Architectural Review Board Agenda  
4:00 PM Wednesday, July 27, 2022  
Sussex Civic Center – Village Board Room Second Floor

TO: Architectural Review Board  
FROM: Jeremy Smith, Village Administrator  
RE: ARB meeting for July 27, 2022  
DATE: July 18, 2022

### **III. Consideration and possible action on the site, architecture, lighting, landscape and sign plans for Industrial Controls (N56W24842 North Corporate Circle).**

The site location of the addition in green.

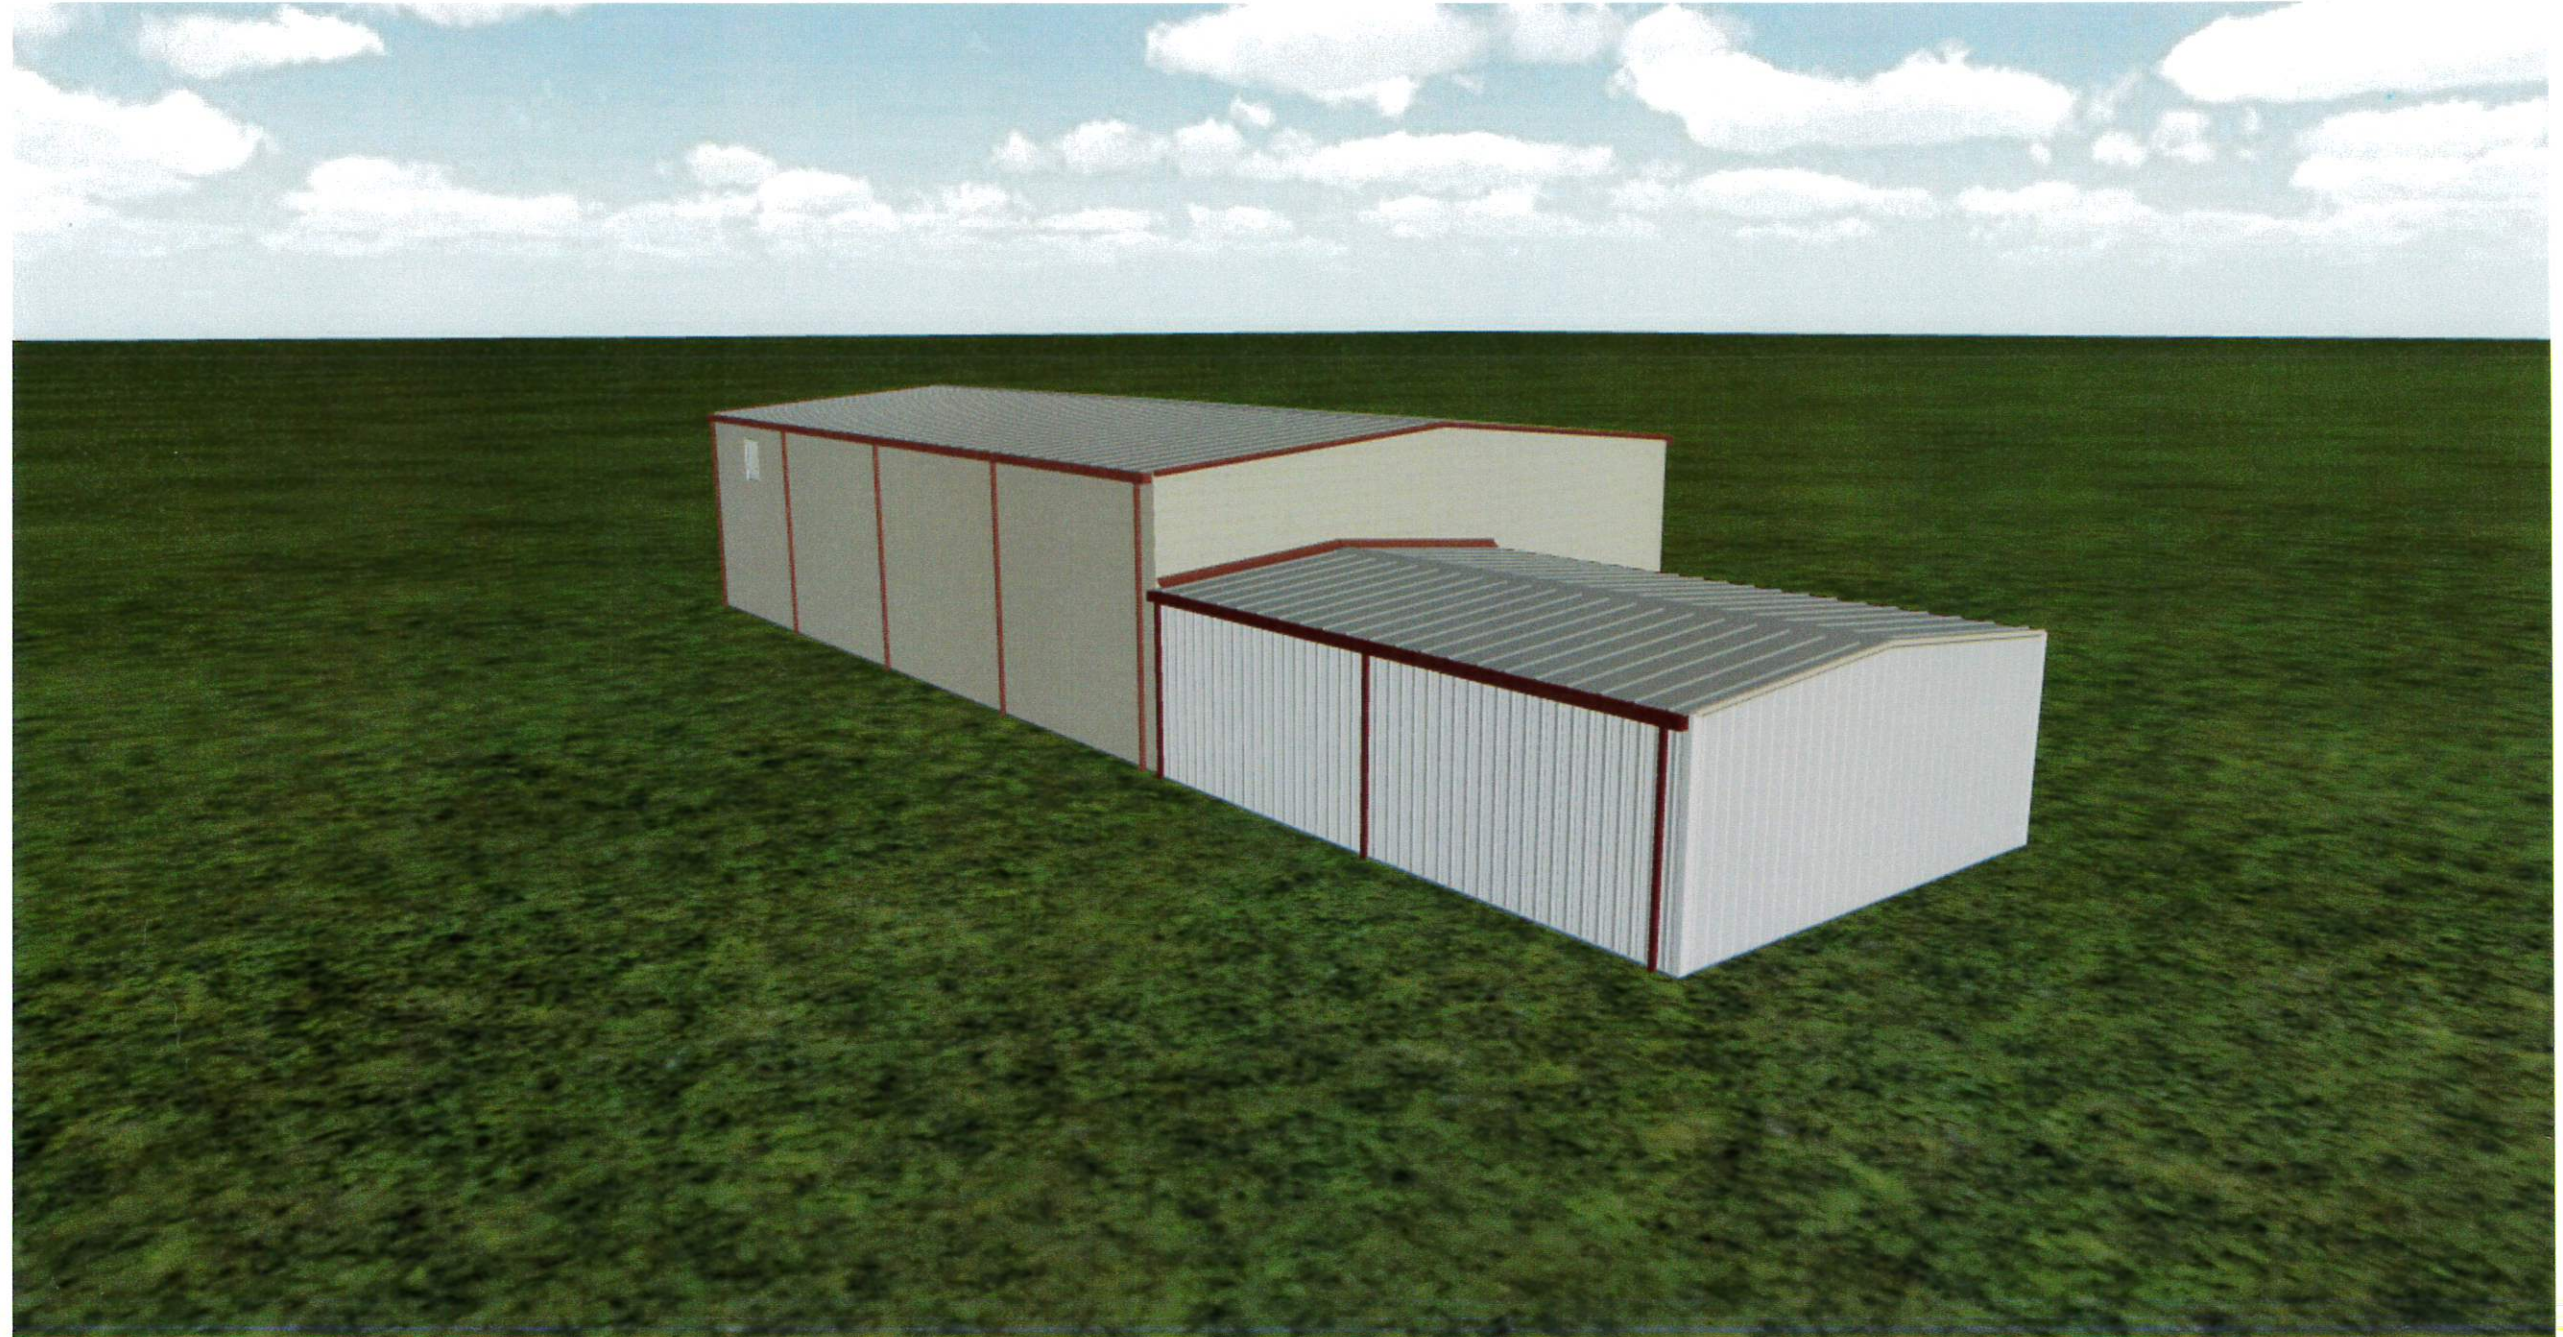
- The Building is to be clad in Lannon stone/cream city brick (Only the upper half of the building will be visible above the fence line.
- 3 windows should be added on the southern elevation
- No additional lighting has been proposed.
- The metal roof should be reviewed by the Board

**Staff Recommendation:** Staff recommends the ARB recommend approval of the architectural plan, for H.M. Brandt subject to the additions of windows per the report, and the metal roof must meet the design standards and any other conditions from the ARB.
